## REVISED Certificate of Appropriateness Case Report

*Filing Date:* December 2, 2010  
*Case No.:* **2010.1072A**  
*Project Address:* **937 VALENCIA STREET**  
*Historic Landmark:* Liberty-Hill Historic District  
*Zoning:* Valencia Street Neighborhood Commercial District  
50-X Height and Bulk District  
*Block/Lot:* 3609/036  
*Applicant:* Jane Martin  
Shift Design Studio  
2717 Harrison Street  
San Francisco, CA 94110  
*Staff Contact* Richard Sucre - (415) 575-9108  
richard.sucre@sfgov.org  
*Reviewed By* Timothy Frye - (415) 575-6822  
tim.frye@sfgov.org

**DATE:** April 6, 2011  
**TO:** Architectural Review Committee of the Historic Preservation Commission  
**FROM:** Rich Sucre, Historic Preservation Technical Specialist, (415) 575-9108  
**RE:** **Review and Comment for 937 Valencia Street**  
**Case No. 2010.1072A**

A2.0

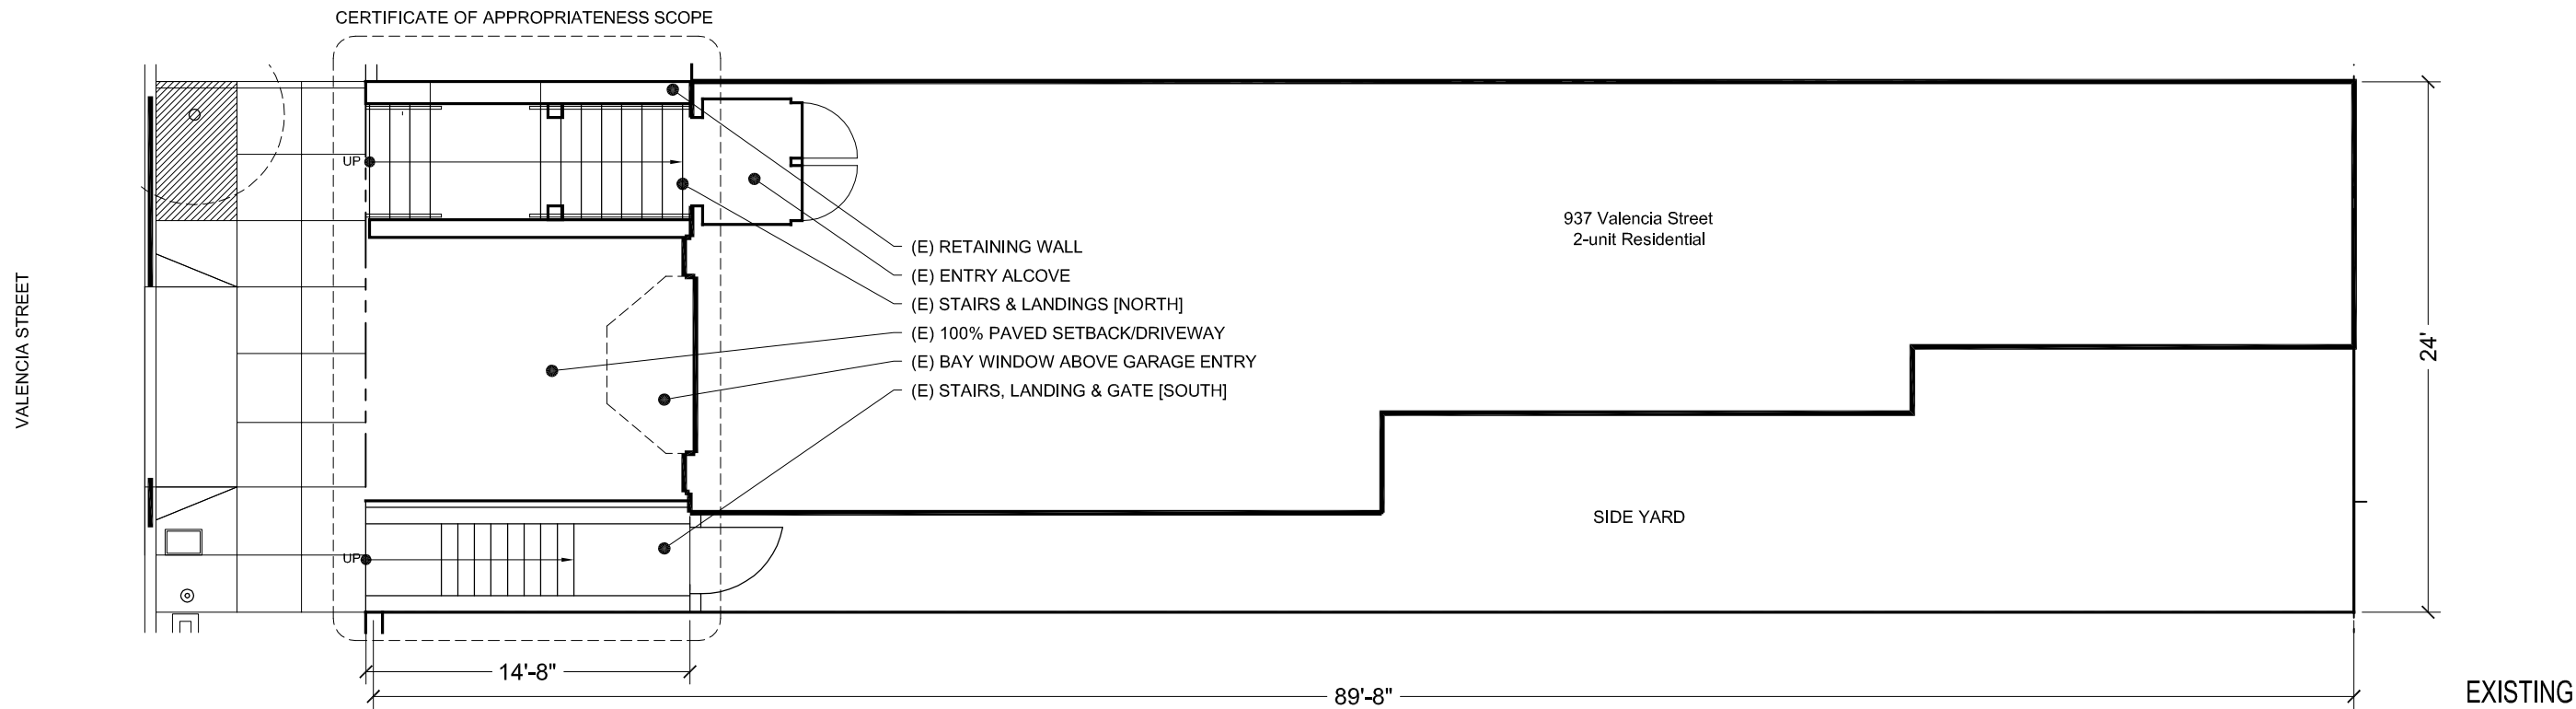
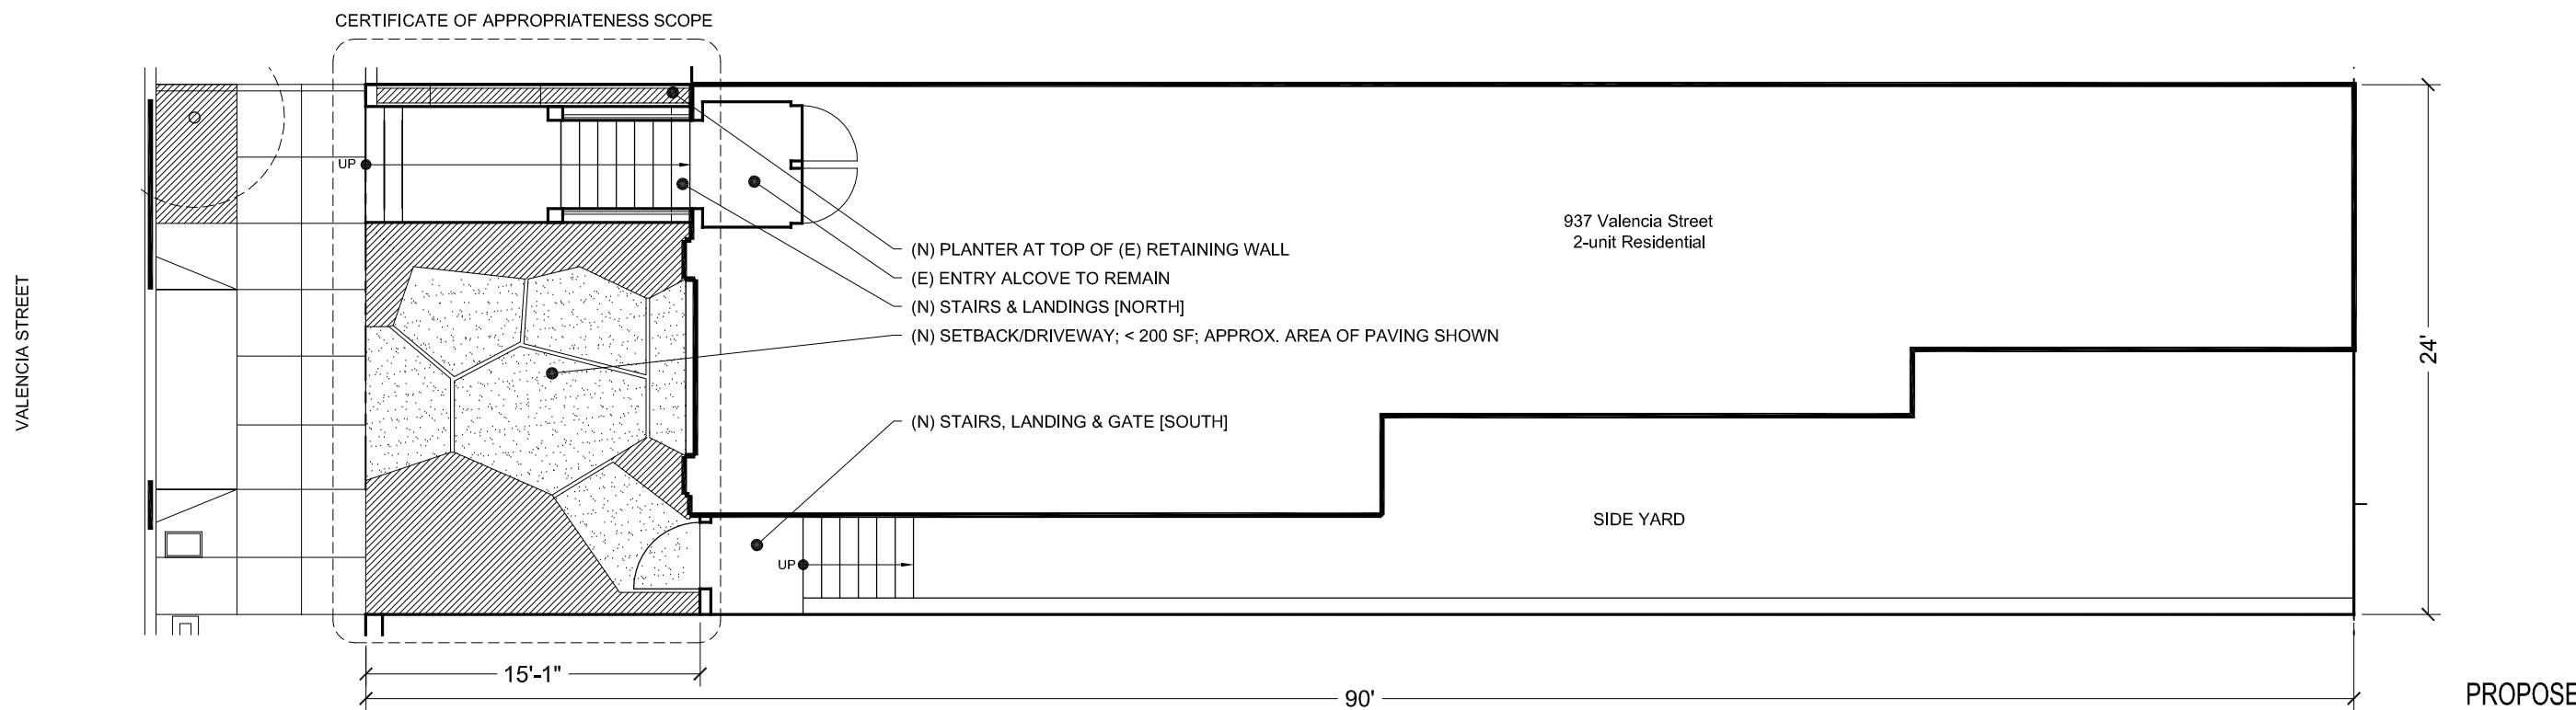
\* *Update:* Based upon comments from ARC, the Project Sponsor has revised the proposed project as described in Sheets A2.0 to A6.2 and as shown in the provided renderings (See Attachments). This scheme entails information on the materials and design of the new staircases and doors, and includes two concrete newel posts at the base of the main entry stair landing.

In comparison to earlier schemes, the revised proposed project has eliminated the landing shelf at the main entry staircase, the concrete garden walls, and the aluminum in-fill panels within the handrails.

1. As part of the Building Permit, details of the handrail design and decorative metalwork shall be submitted for review and approval by Planning Department Preservation staff. The handrails and metalwork shall be of a similar character to other examples found within the historic district.
